Riverside County Transportation Department
Summary of Bids
Advertised: June 2, 2015 (Agenda Item: 3-28)
Addenda: 1 (6/25/2015), 2 (7/09/2015), 3 (7/16/2015), 4 (7/24/2015), 5 (7/29/15), 6 (8/6/2015)
Bids Open: 2 pm Date: Wednesday, August 12, 2015

PROJECT: Clinton Keith Road Construction Project - Phase 2
From Whitewood Road to Leon Road
In the City of Murrieta and French Valley Area
Project No. B2-04722

MODIFICATIONS / CLARIFICATIONS TO SPECIAL PROVISIONS:

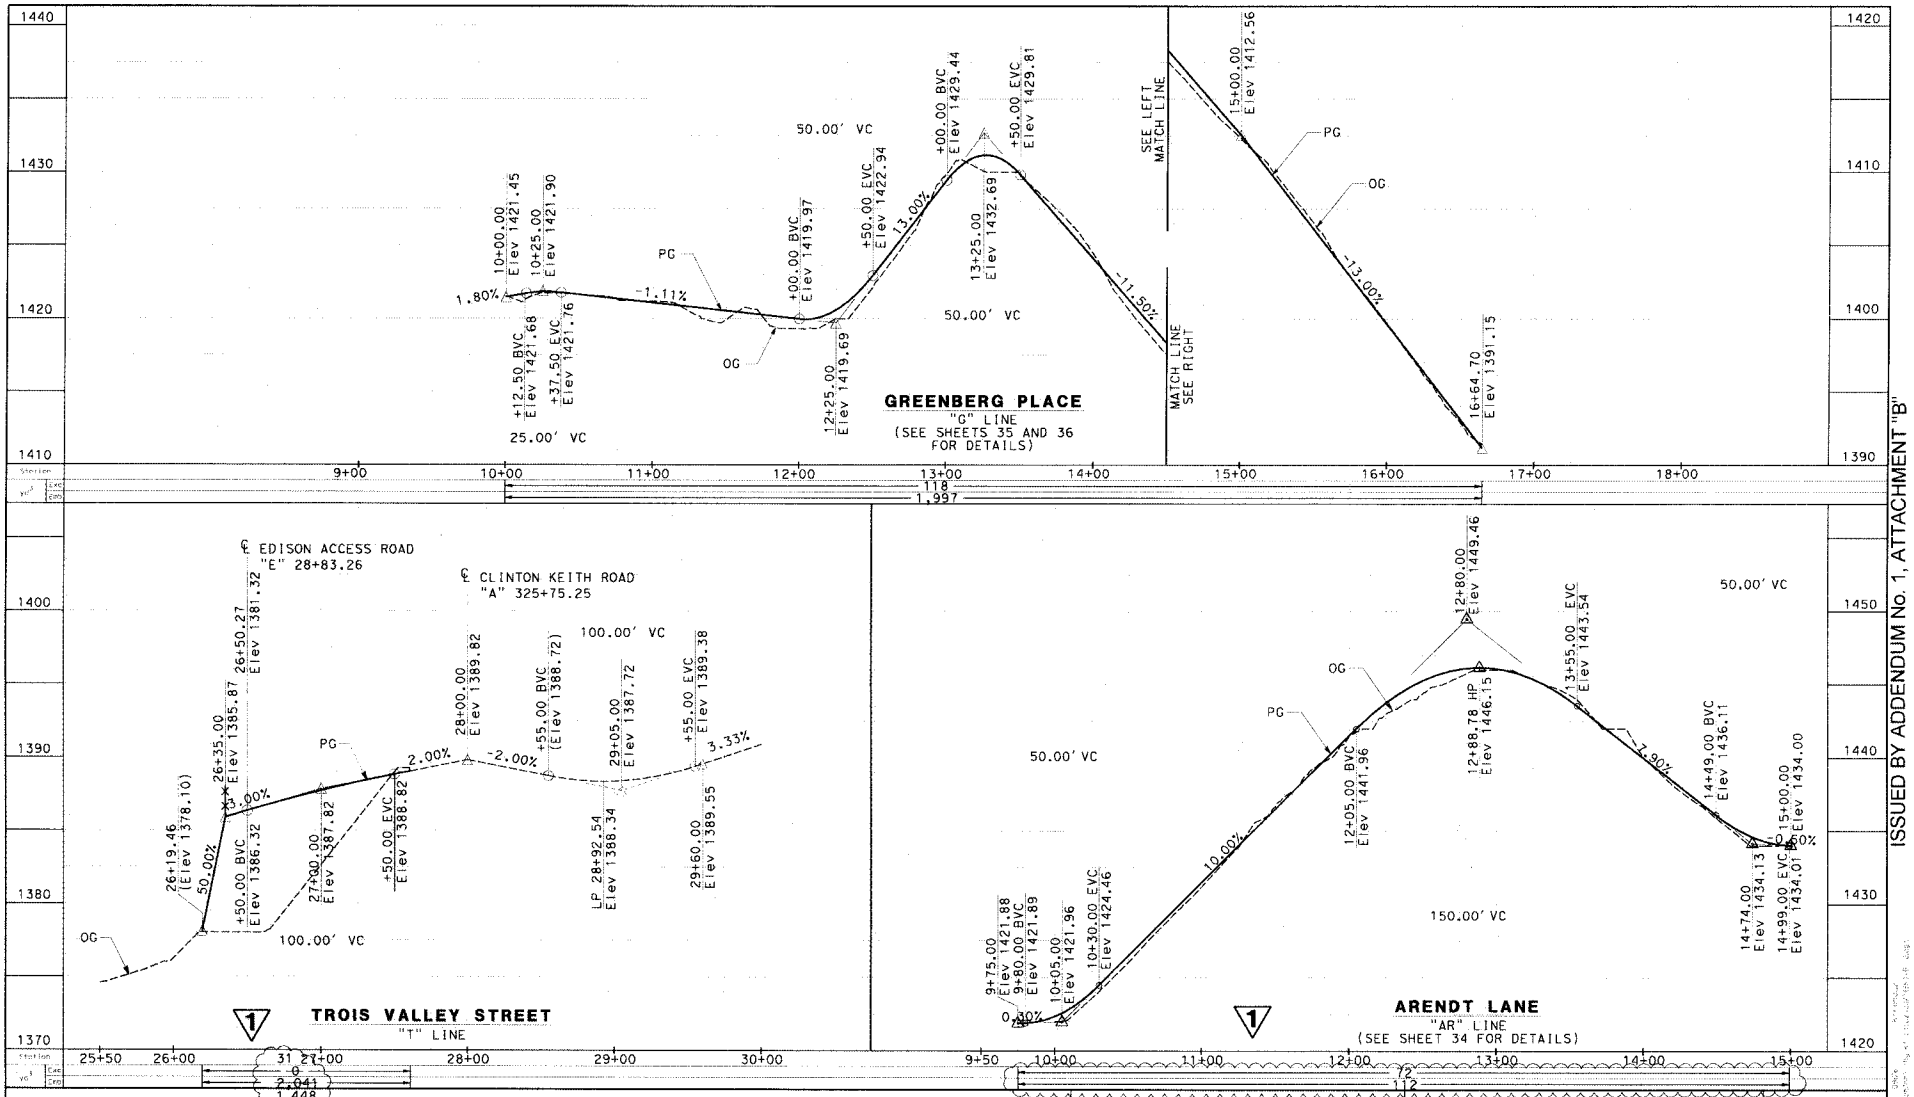
1 REVISED PER ADDENDUM No. 1

EDISON ACCESS ROAD (GRADED DIRT ROAD)
(WEST OF TROIS VALLEY STREET, NORTH OF CLINTON KEITH ROAD)
"E1" LINE

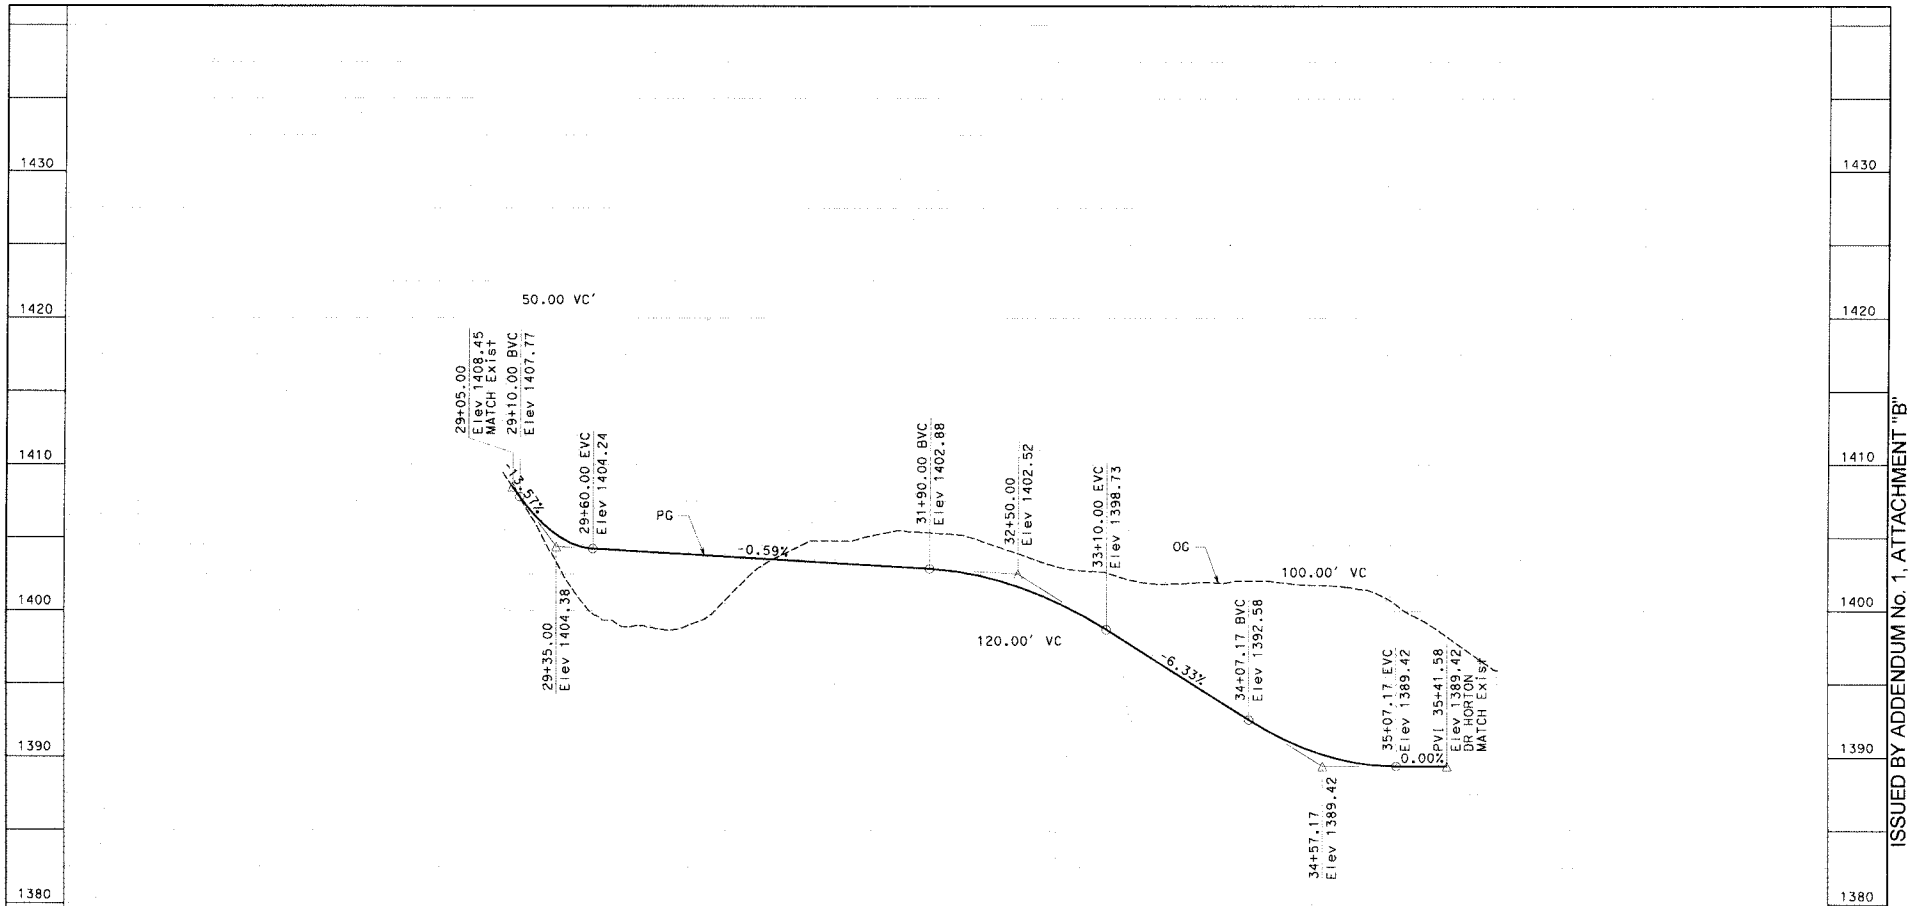
1 REVISED PER ADDENDUM No. 1
